UNITED STATES PATENT AND TRADEMARK OFFICE

APPLICATION NO.	FILING DATE	FIRST NAMED INVENTOR	ATTORNEY DOCKET NO.	CONFIRMATION NO.
09/635,549	08/10/2000	Yevgeniy Eugene Shleyn	US000209	7153

Office Action Summary

FIG. 3

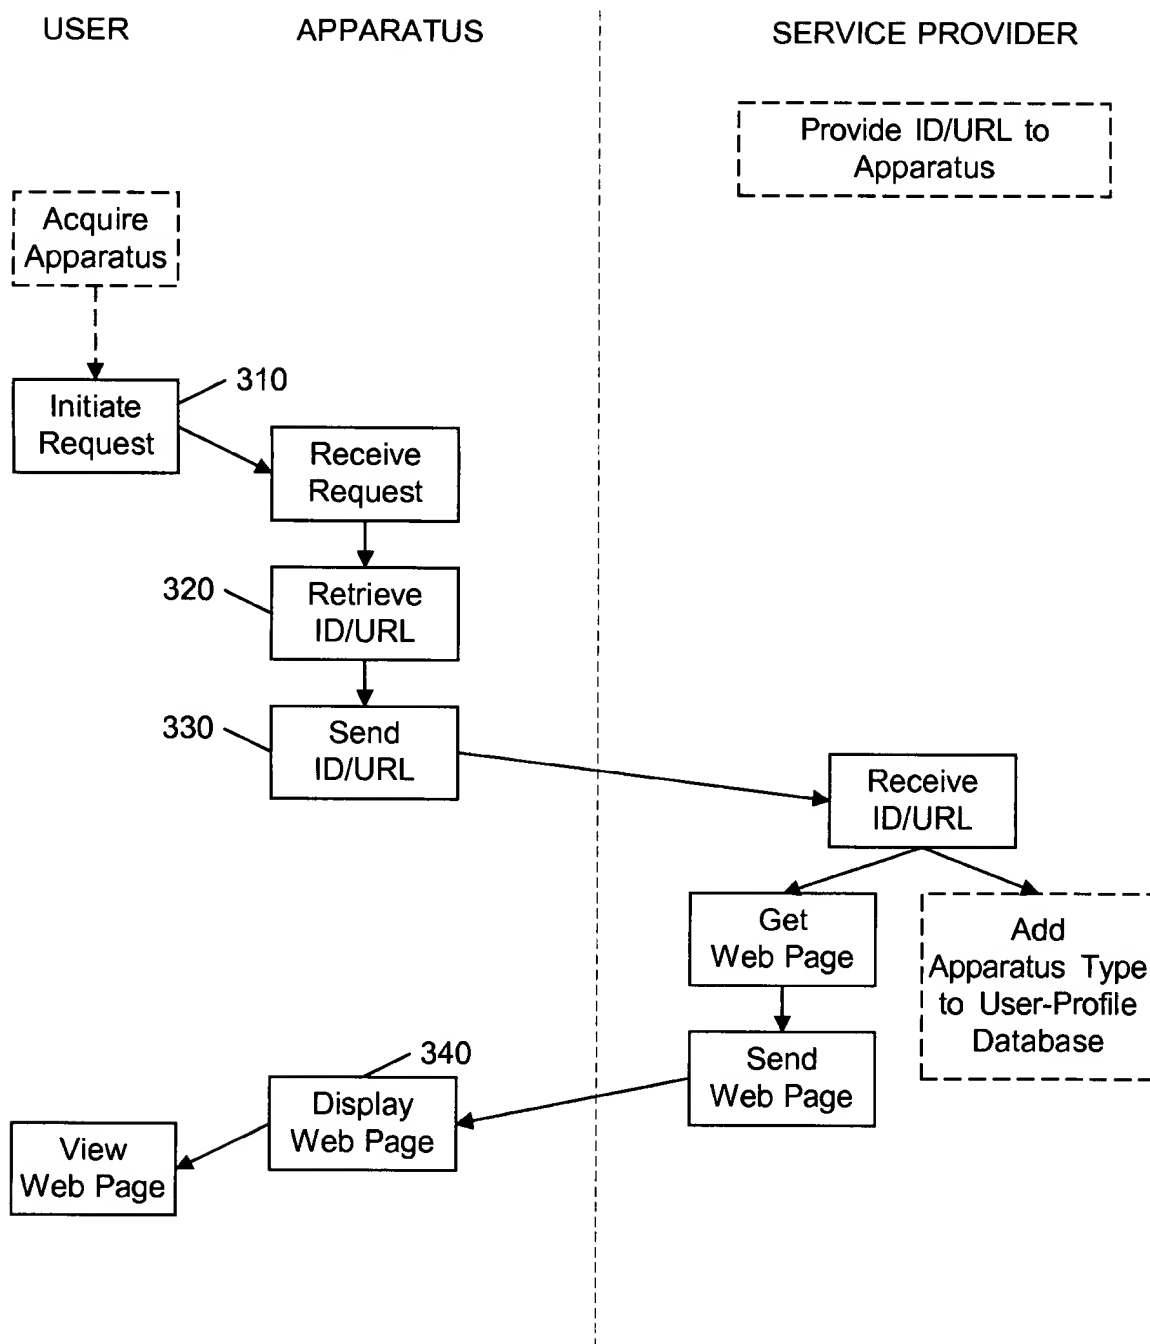
indicated by a specific URL”) in the original specification that teaches the use of URL to retrieve the content data from the remote server. What kind of a proxy device 202 that can perform such function? Moreover, there is no teaching in the original application as amended drawing (4/4/07), especially the newly added figure 3 which contains a new matter and it will not be entered. The newly added specification does not sufficiently describe this newly added figure either. Applicant is reminded that each elements or items of drawing must be labeled and sufficiently described in detail. And, the applicant is suggested to cite where in the specification that teaches the newly added features of figures 1-3.

Do not
enter
7/1/07
K

new matter
